## ADDENDUM

NO. 3

**PROJECT NAME:** Johnson High School 2025 Additions and Renovations

**ADDENDUM DATE:** 15 May, 2025

GRADING PLAN  
(1 OF 2)

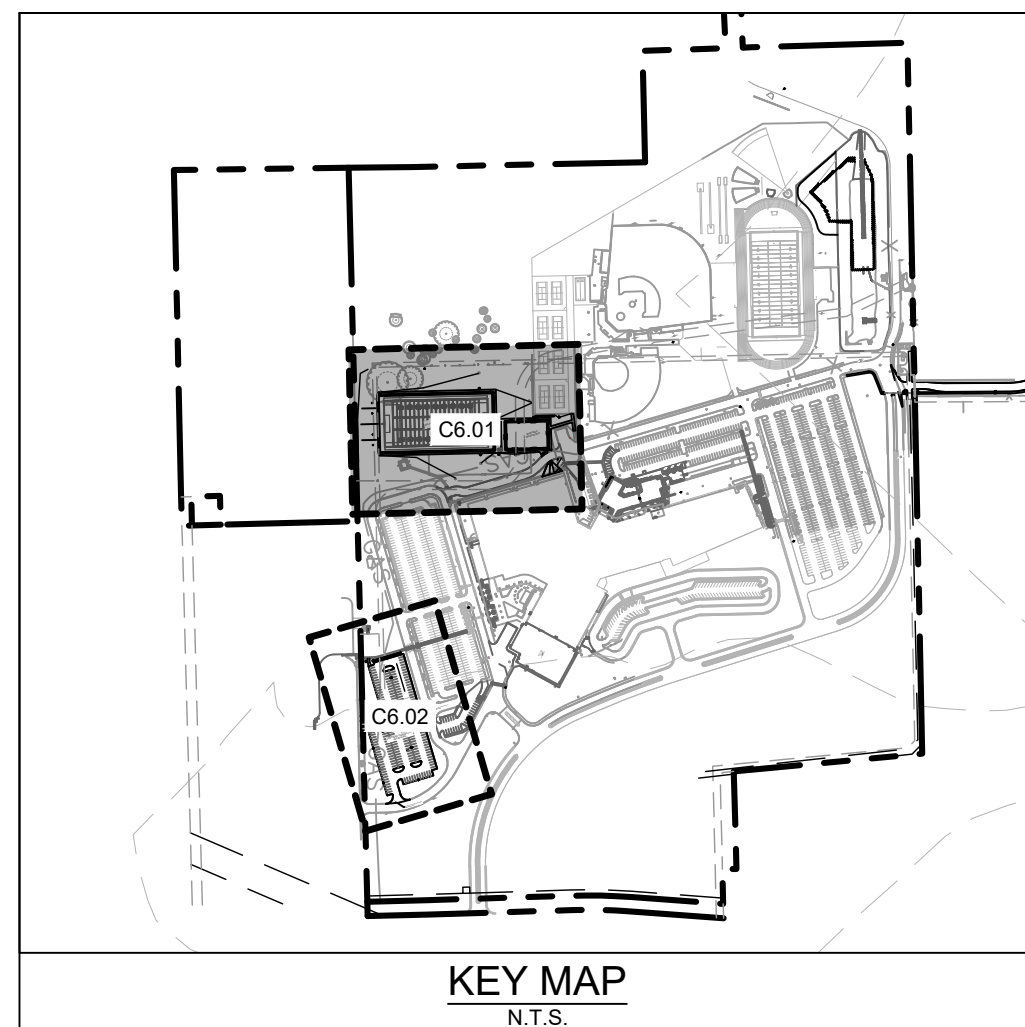
AD No 3, Civil Item 2: **To the Drawings, Sheet C6.01, "GRADING PLAN (1 OF 2),"**

1. Modification of MAC footprint.

DIMENSION CONTROL  
PLAN (1 OF 2)

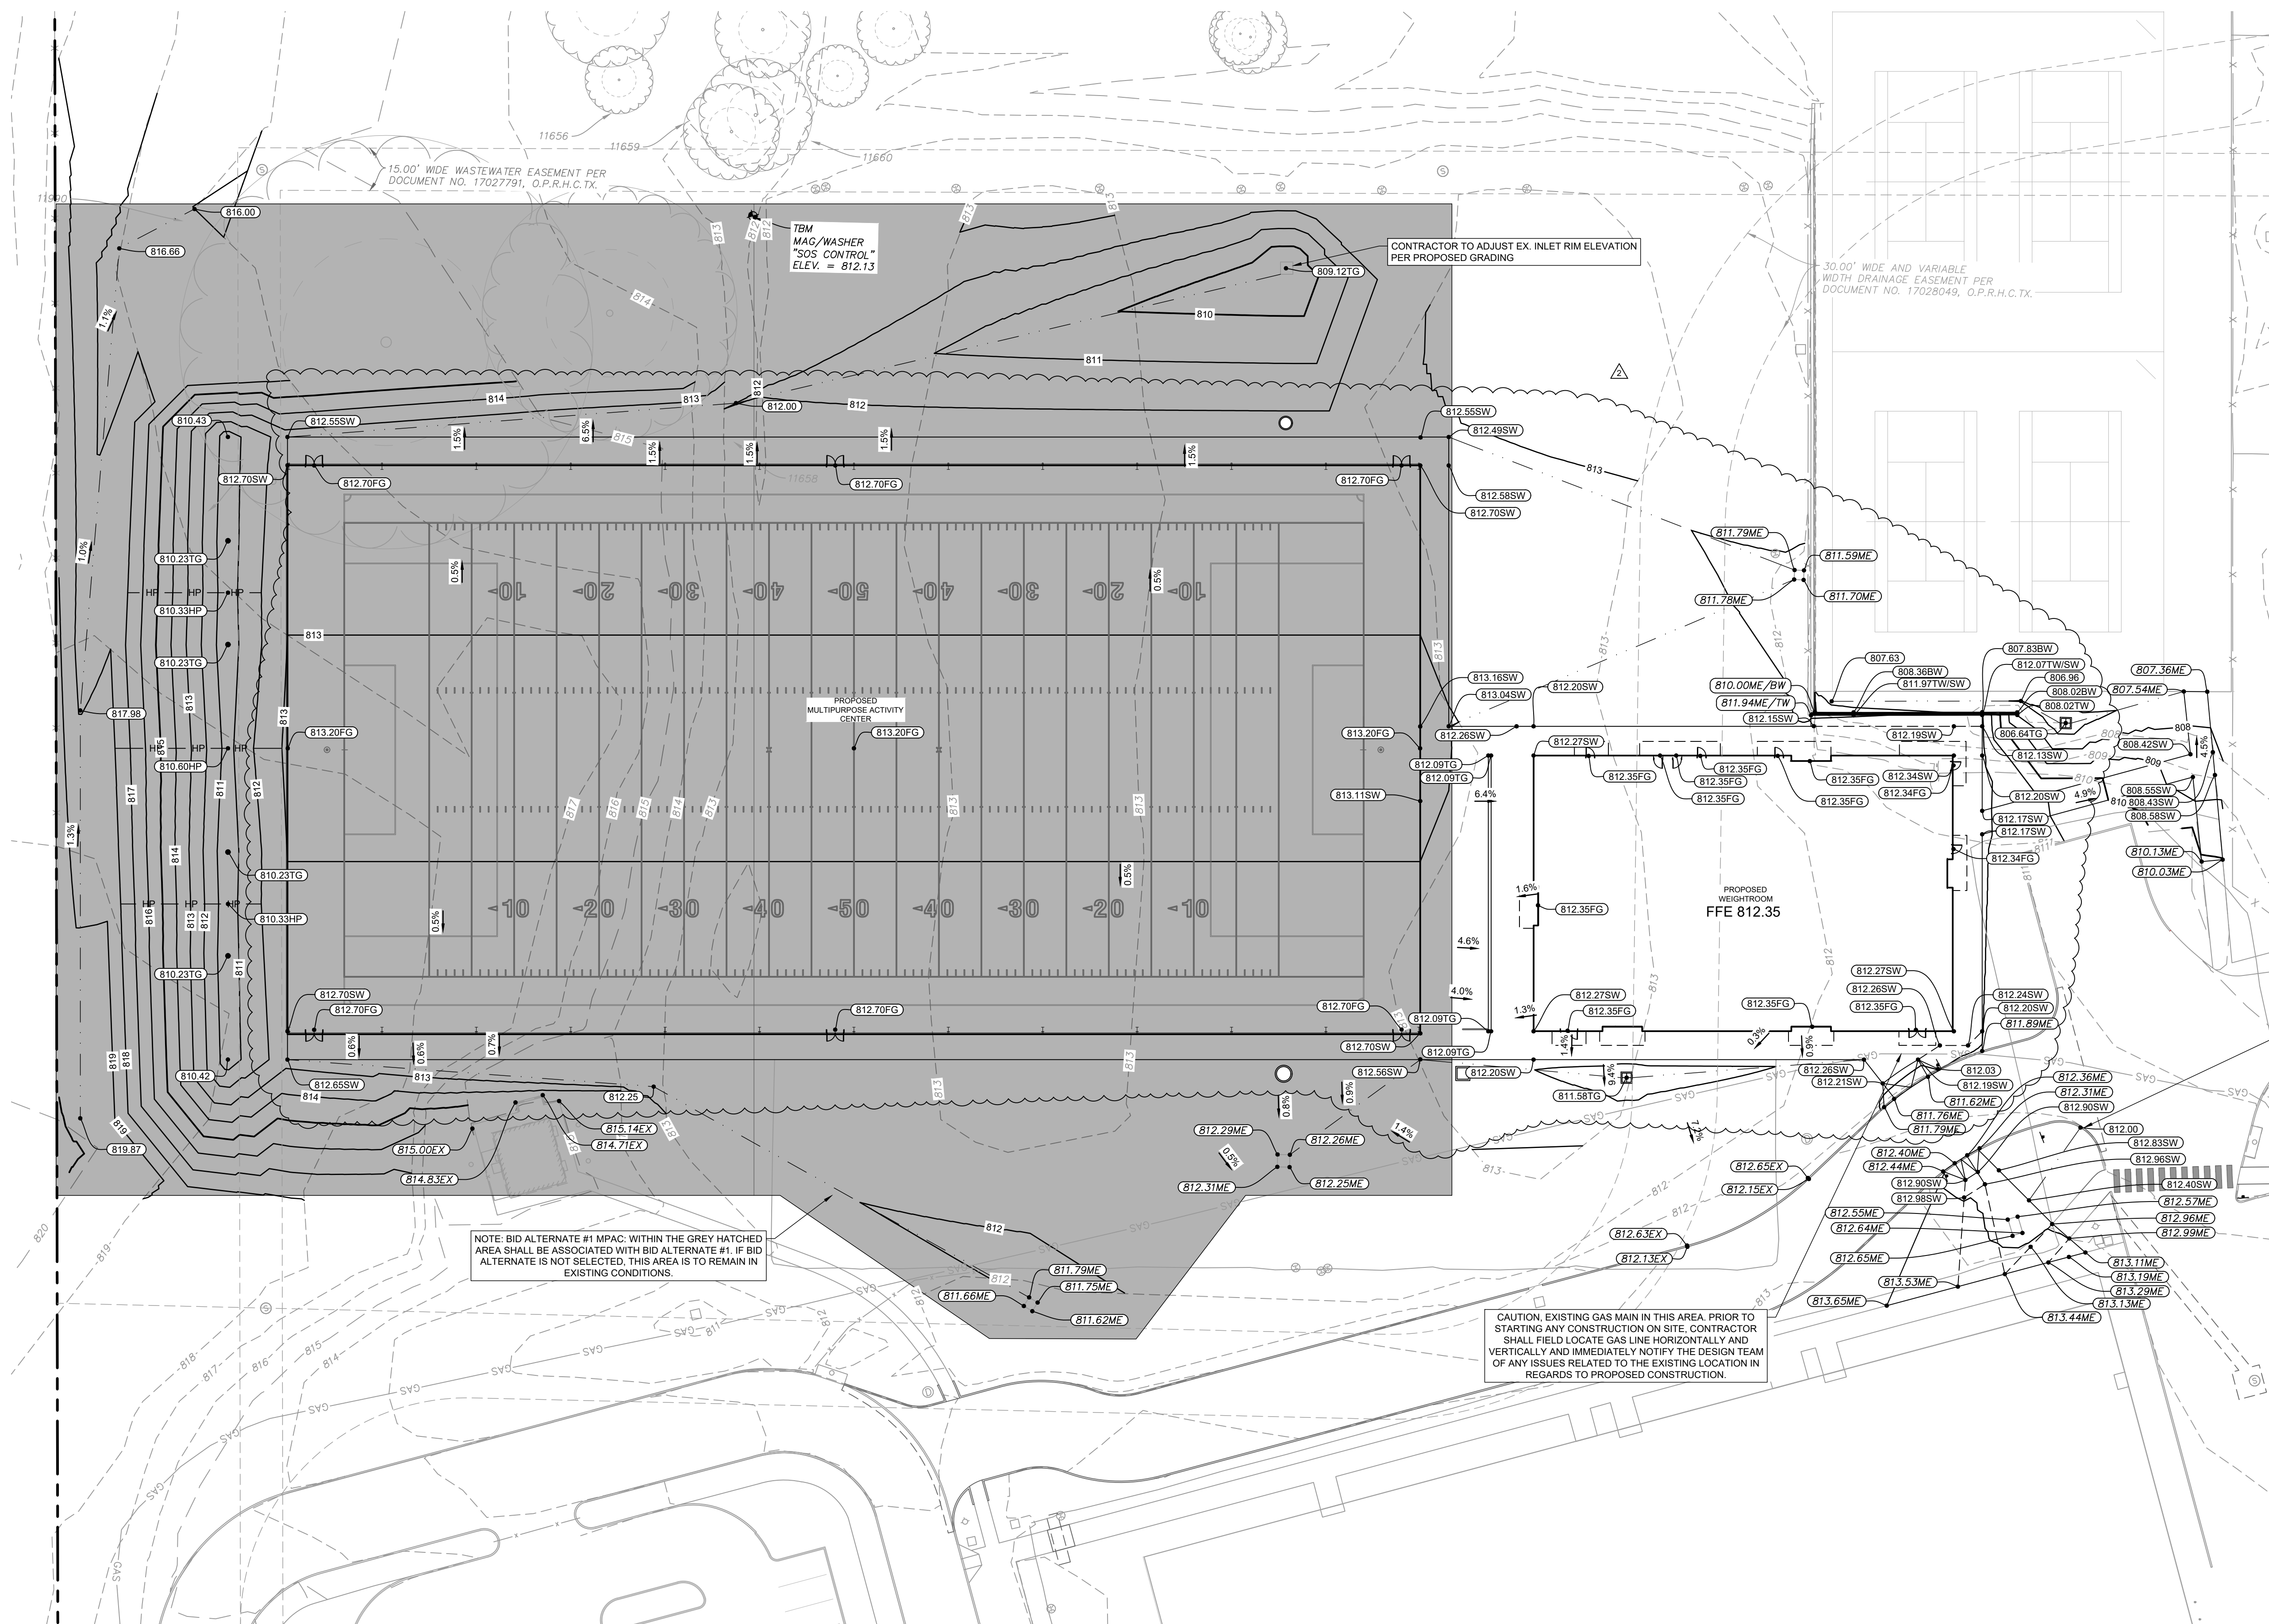
AD No 3, Civil Item 1: **To the Drawings, Sheet C4.01, "DIMENSION CONTROL PLAN (1 OF 2),"**

1. Modification of MAC footprint.

UTILITY PLAN  
(1 OF 2)

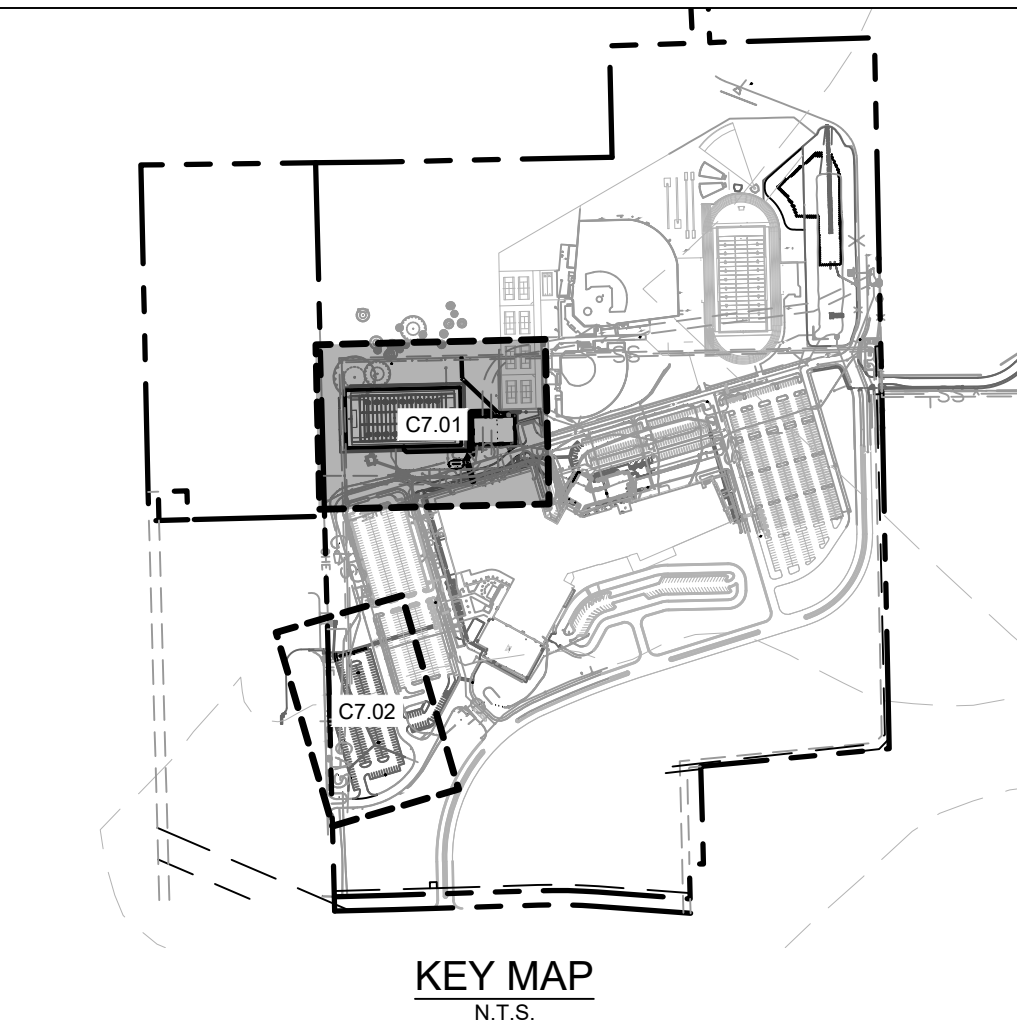
AD No 3, Civil Item 3: **To the Drawings, Sheet C7.01, "UTILITY PLAN (1 OF 2),"**

1. Addition of utility vault.

STORM PLAN  
(1 OF 2)

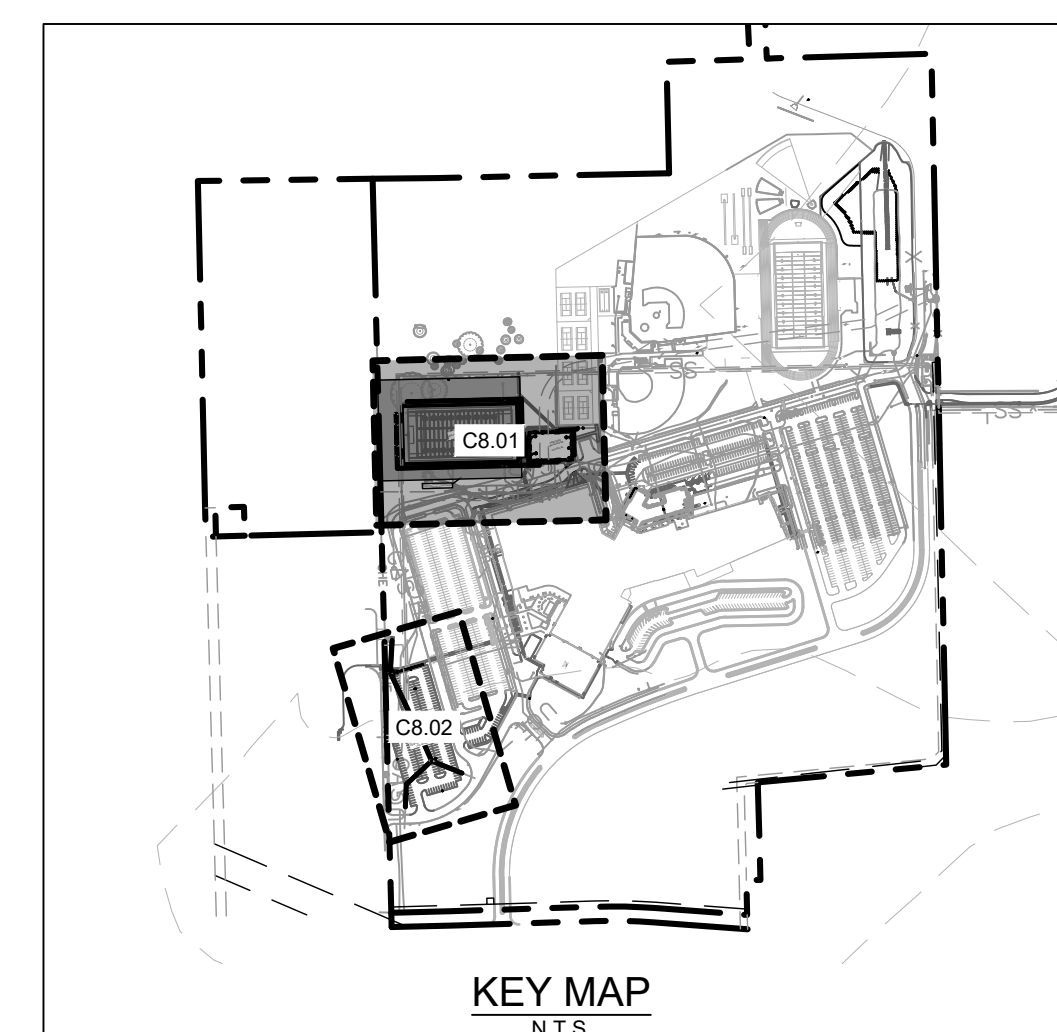
AD No 3, Civil Item 4: **To the Drawings, Sheet C8.01, "STORM PLAN (1 OF 2),"**

1. Addition of storm line to utility vault

SURFACE PLAN  
- ALTERNATE 1

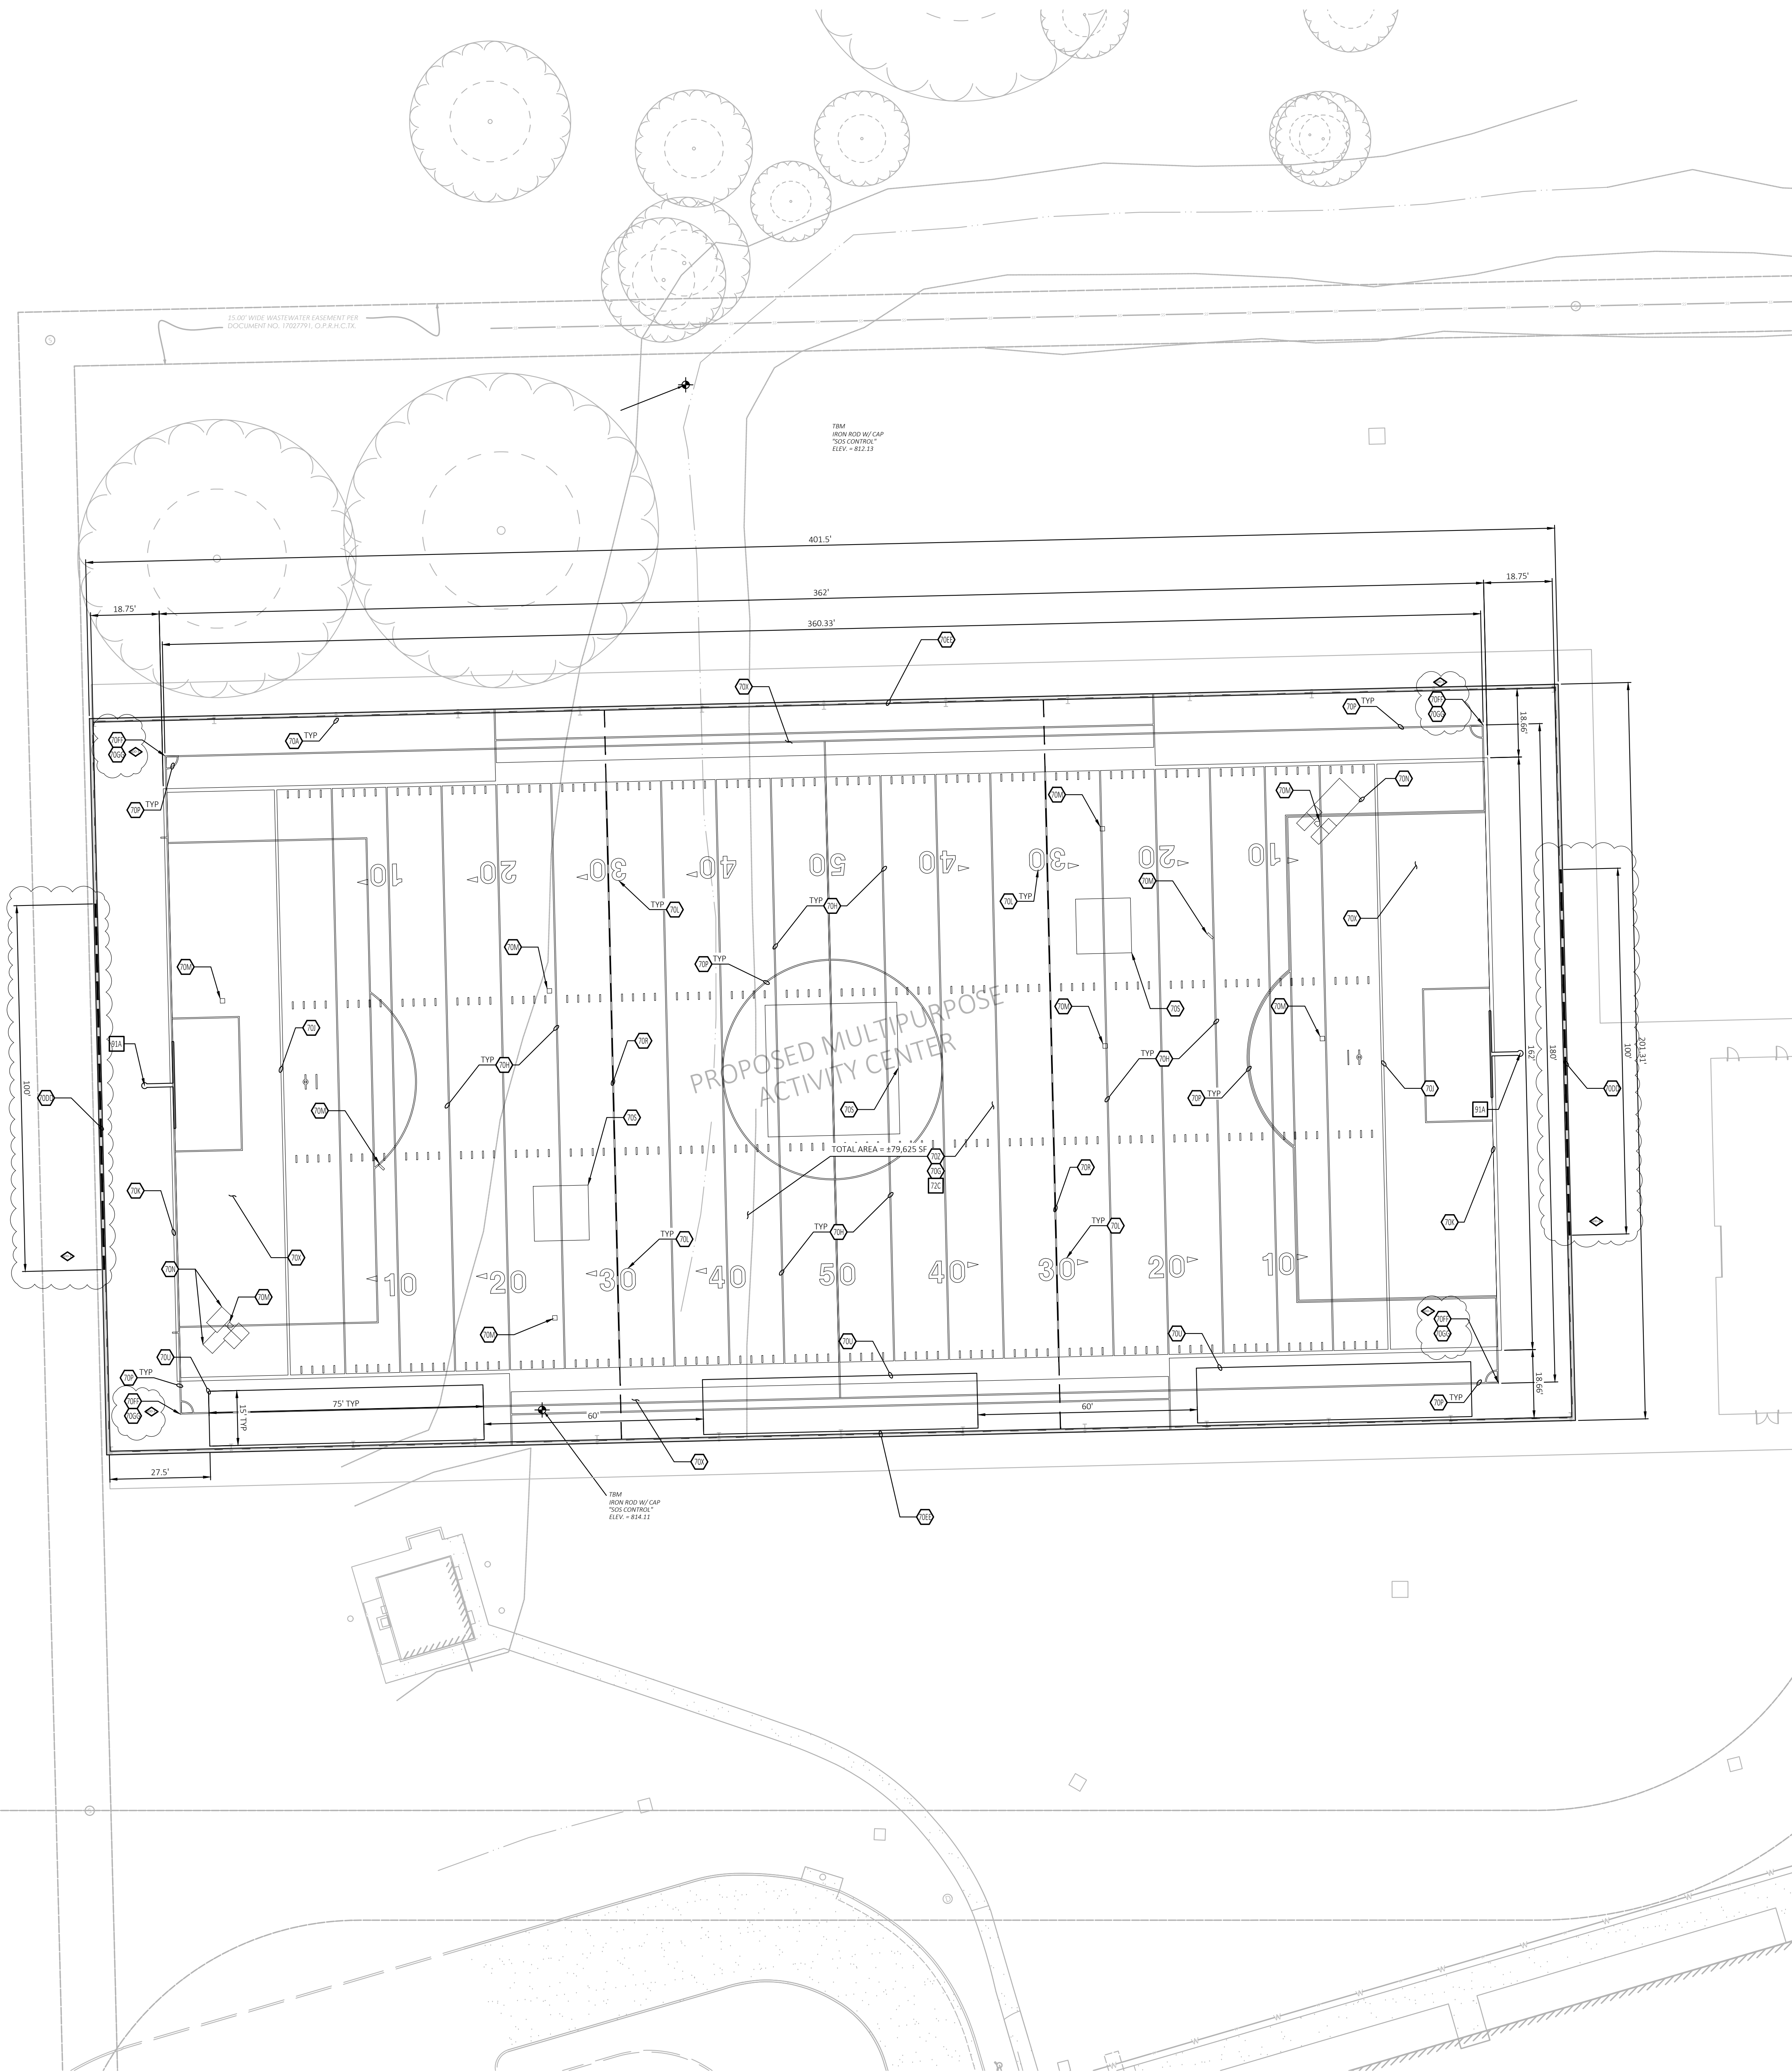
##### AD No 1, Sports Item 1: To the Drawings, Sheet F1

- 1) Tension netting behind football goal posts have been adjusted to be 100 ft long.
- 2) Added note 70FF to the sheet and labeled it at all four soccer field corners.
- 3) Added note 70GG to the sheet and labeled it at all four soccer field corners.
